# Final Precursor Analysis

Accident Sequence Precursor Program—Office of Nuclear Regulatory Research

Summer	Turbine-driven emergency feedwater pump discharge valve found isolated	
Event Date: 9/21/2000	LER: 395/00-006	$\Delta\text{CDP} = 4 \times 10^{-6}$

Figure 2 Summer loss of offsite power event tree showing sequence 18 transfer to station blackout event tree (Fig. 3)

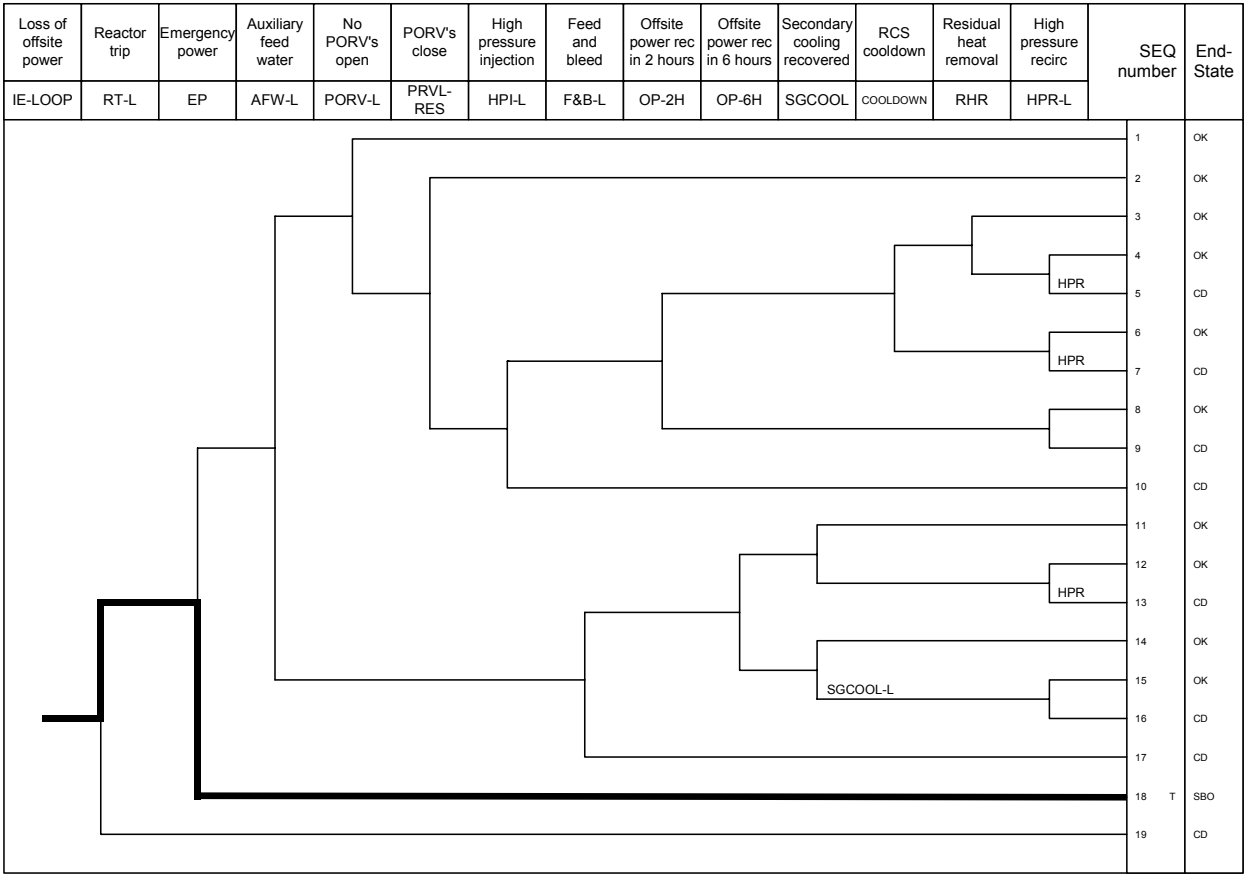
High temperature seals were installed on two of three reactor coolant pumps (RCPs) at the time of the event. The 'B' RCP seal was changed during the refueling cycle 12 that started in October 2000. High temperature seals had been installed in refueling cycles 10 and in 11 in RCPs 'C' and 'A' respectively prior to the September 2000 event.

The licensee stated that new seals were installed in only two of three RCPs in the reactor coolant system prior to the identification of operating condition. Since one old RCP seal would control the probability and the timing of seal failure, we judged that no quantification changes to Loss of Offsite power event tree in the preliminary precursor analysis were necessary.
